## **BCA ASSESSMENT REPORT**

**Oakdale West Estate, Kemps Creek  
Building 4A & 4B**

**Prepared For:  
Goodman Property Services Pty Ltd**

Date: 04 October 2022

Figure 1 – 4A & 4B Perimeter Vehicular Access per BCA C2.4

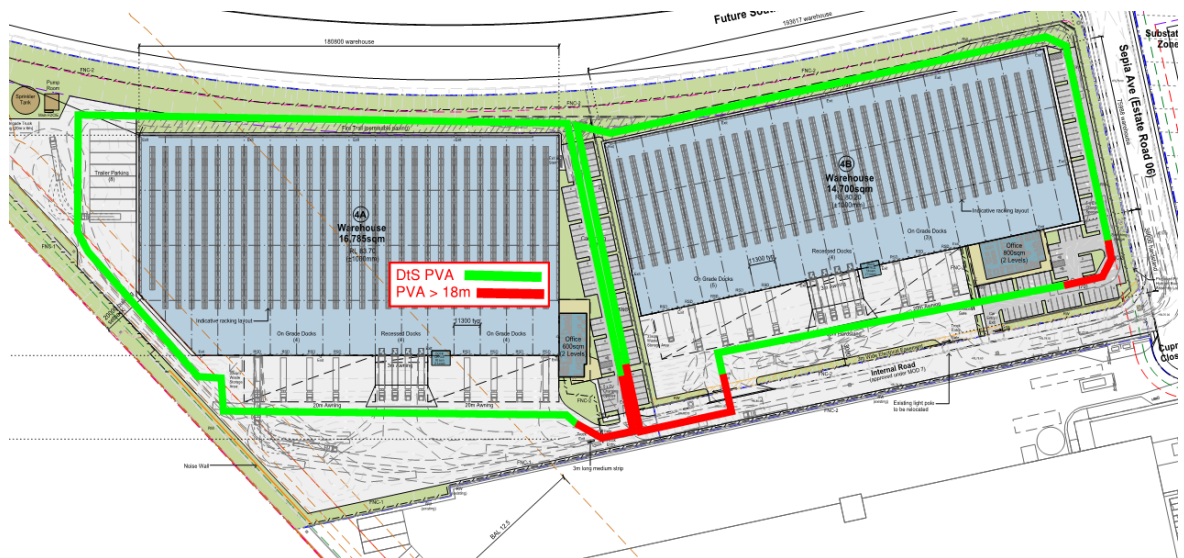
**Comments:** The proposed buildings do not comply with the provisions of C2.4 and thus the following non-compliance areas are identified on the site plan that are required to be addressed as a Performance Solution by the Fire Safety Engineer:

- Site 4A: The furthest part of the vehicular access path is greater than 18m from the external wall, along the Eastern corner of the building around the carpark entry.
- Site 4B: The furthest parts of the vehicular access path is greater than 18m from the external wall, along the Southern corner of the building around the truck entry and in the Eastern Corner around the carpark.

**Note:** It is understood that a Performance Solution is proposed to address the use of permeable paving for the fire trail along the Western Boundary of both buildings. Details are to be included in the Fire Engineering Report prepared by an accredited Fire Engineer.

**Note 1:** The driveways providing vehicular perimeter access must be designed with adequate loading capacities to withstand a fire truck and the gradients of the ramps should take into consideration to the FRNSW Policy 4 Vehicular Access Guideline.

**Note 2:** If the perimeter access paths are reduced to less than 6m in width to accommodate pedestrian egress paths per Clause D1.10 below, this will need to be documented in the Performance Solution.
